## YEAR 5 OF 5 MONITORING REPORT - FINAL

**Five-Mile Branch Stream and Wetland Restoration, Iredell County  
NCDMS IMS ID# 92185**

**Responses to Comments**  
**Draft Year 5 Monitoring Plan**  
**for**  
**Five Mile Branch Stream and Wetland Restoration Site**  
**NCDMS IMS ID # 92185**  
**DEQ Contract# 6036**  
**Comments and Responses**

Photo Point

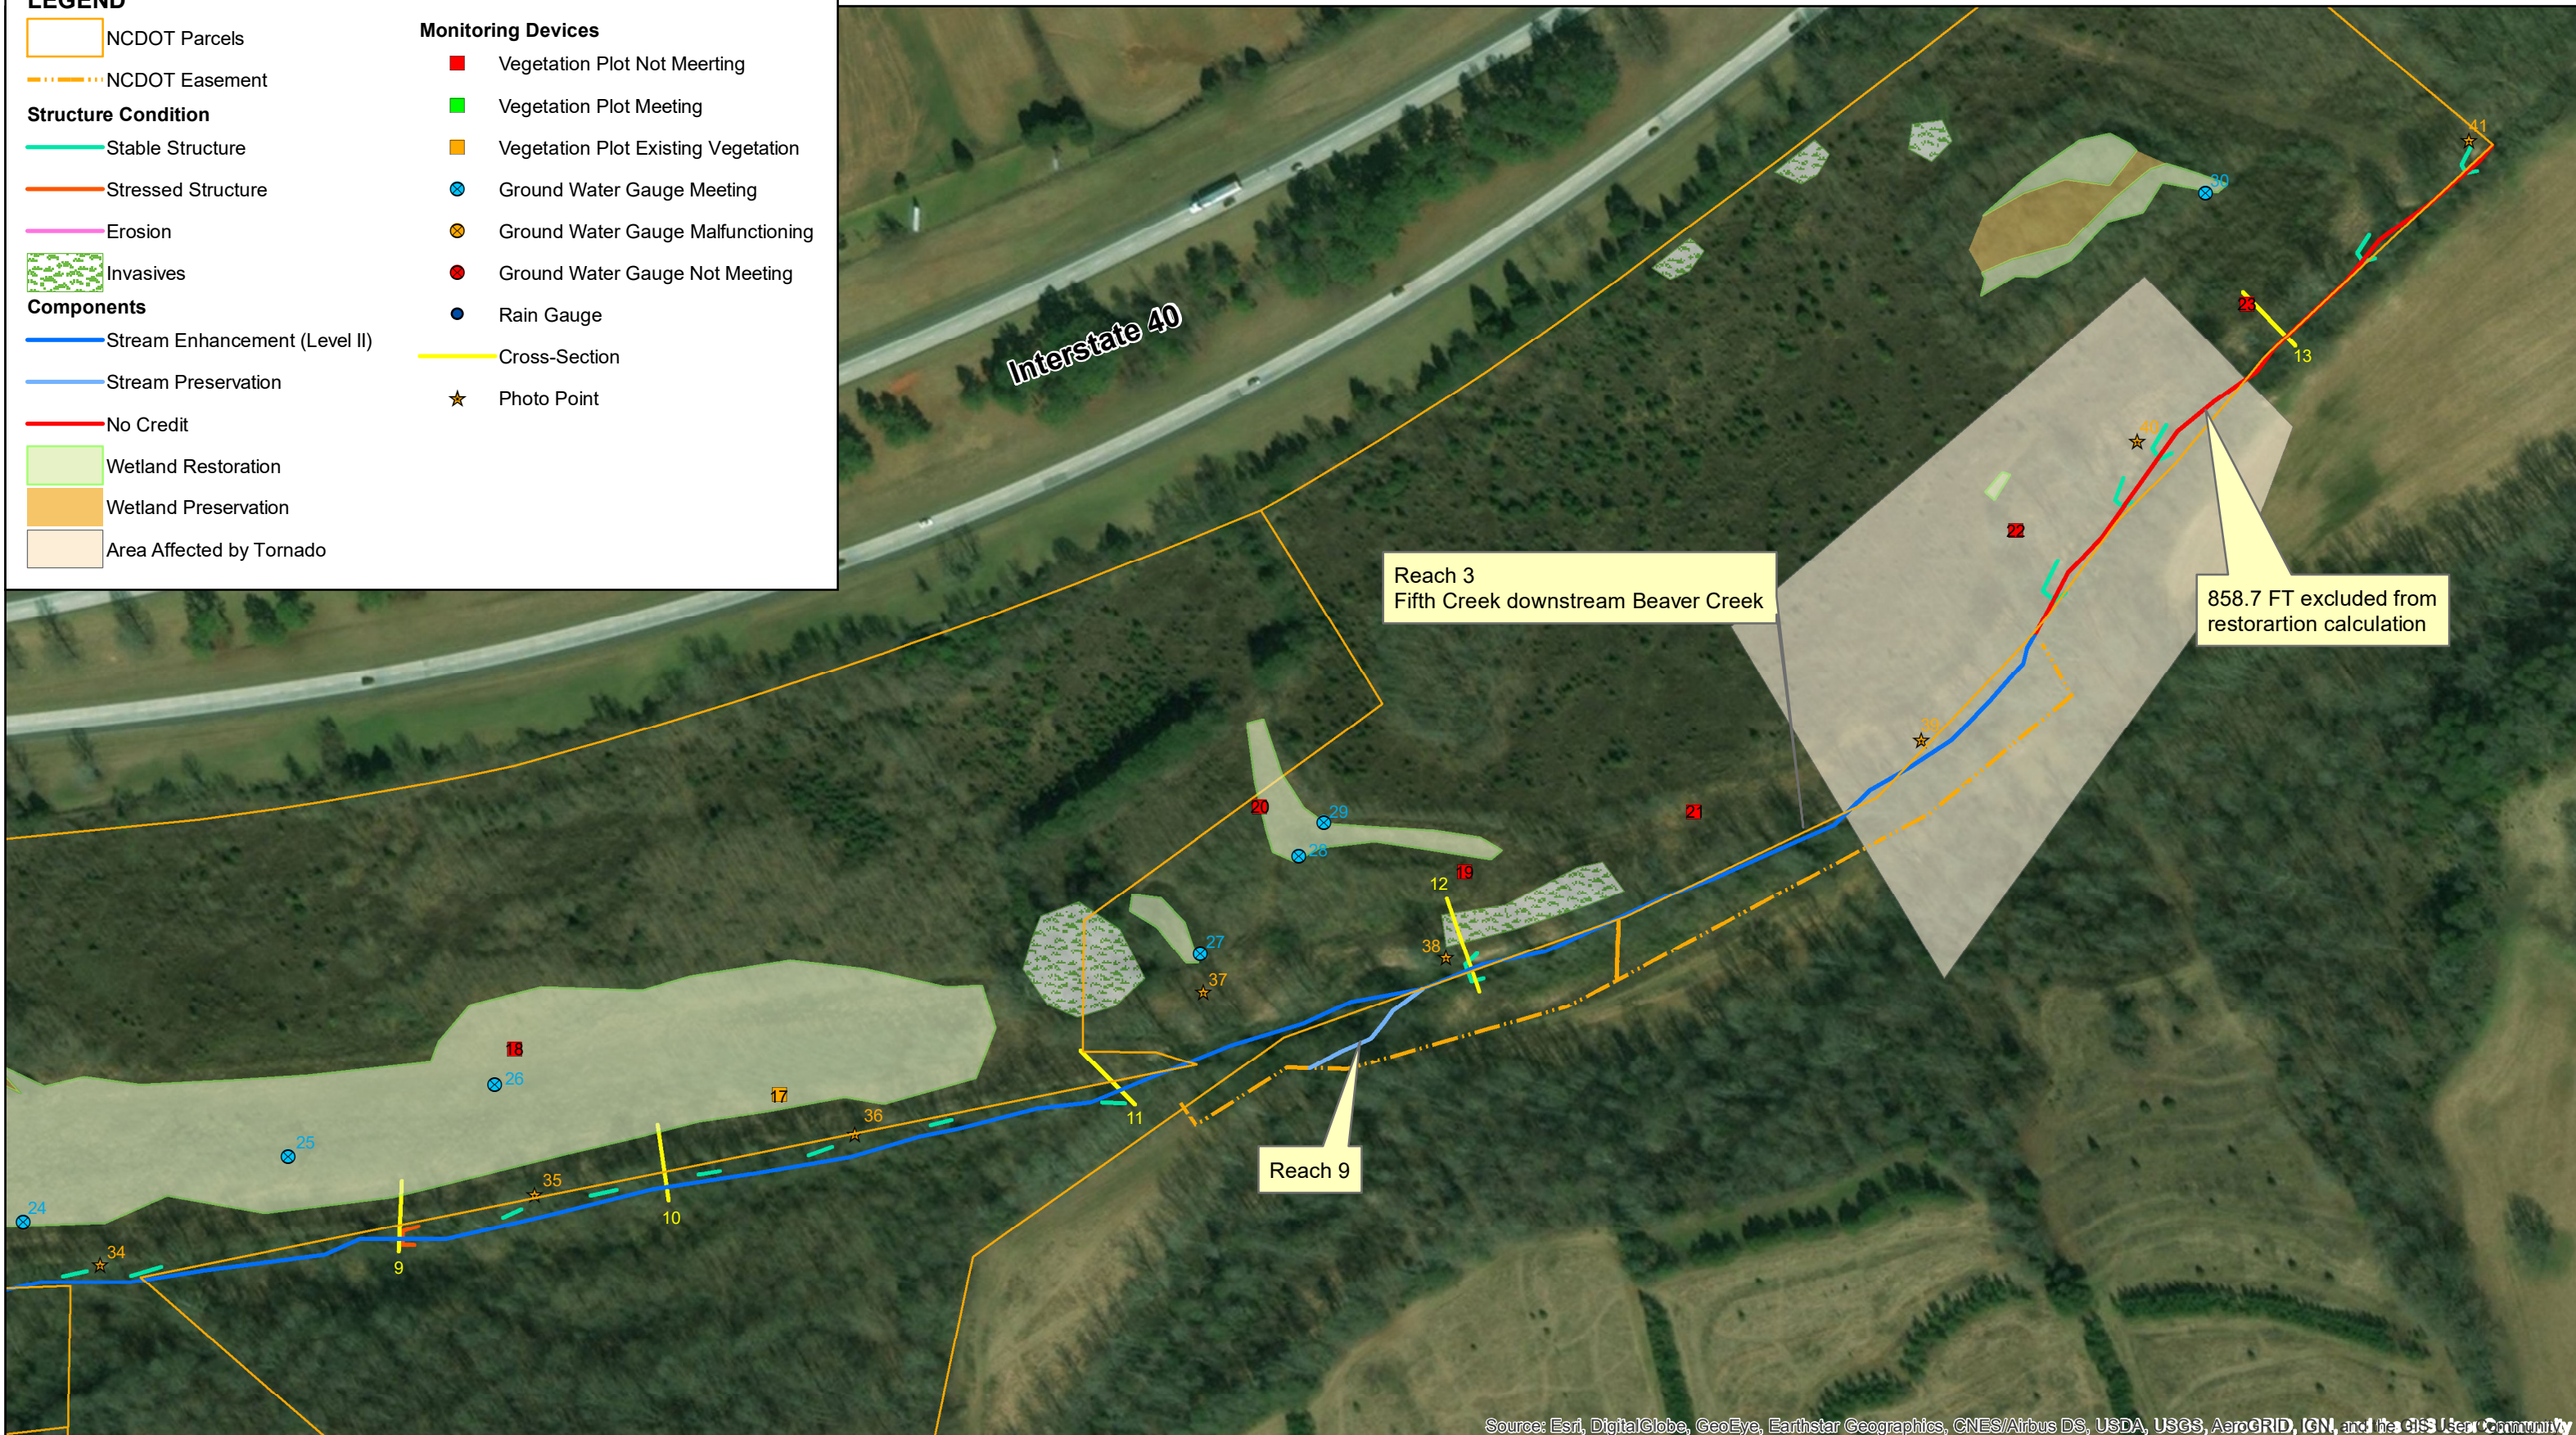
legend. Please terminate stream shapes that are located outside of the project boundary to avoid confusion about project credits.	
012	<b>CCPV Sheets:</b> Please remove the "Year 4 Wetland Delineation" label from the map legend. The project wetlands should be shown/ shaded as "Wetland Restoration" & "Wetland Preservation" with different colors to represent each approach on the maps and in the legends.	The CCPV Sheets were updated.
013	<b>CCPV Sheets:</b> Please include the preservation streams on the CCPV sheets. Please also provide stream names and mitigation approaches (EII; Pres) on the CCPV sheets.	The CCPV Sheets were updated.
014	<b>CCPV Sheets:</b> Please update the aerial to the most recent available.	The CCPV Sheets were updated.
015	<b>CCPV Sheets:</b> If mapped invasive areas have been treated and are dead, please removed them from the CCPV sheets. If updated on the CCPV sheets, please make sure to update Table 6 as well.	The CCPV Sheets were updated.
